**IEEE P 802.20™ V8b**

## **Draft 802.20 Permanent Document**

### **<802.20 Requirements Document – Ver. 8b>**

This document is a Draft Permanent Document of IEEE Working Group 802.20. Permanent Documents (PD) are used in facilitating the work of the WG and contain information that provides guidance for the development of 802.20 standards. This document is work in progress and is subject to change.

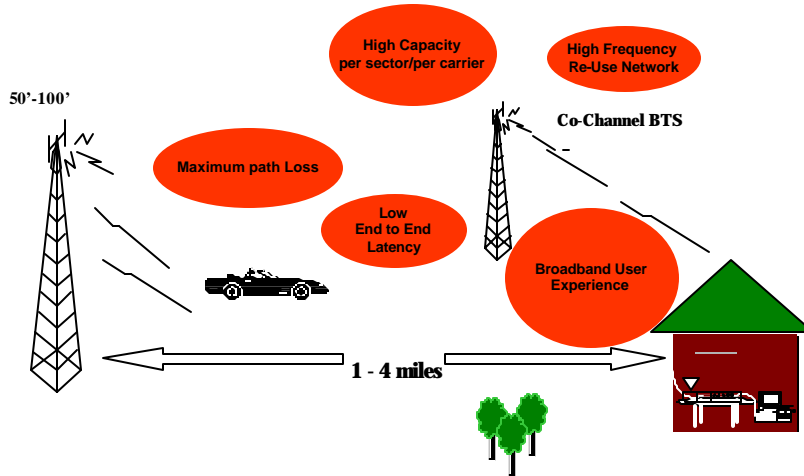
**Comment:** Editor Note: This represents a new version of this picture without any of the details that were in the original version.
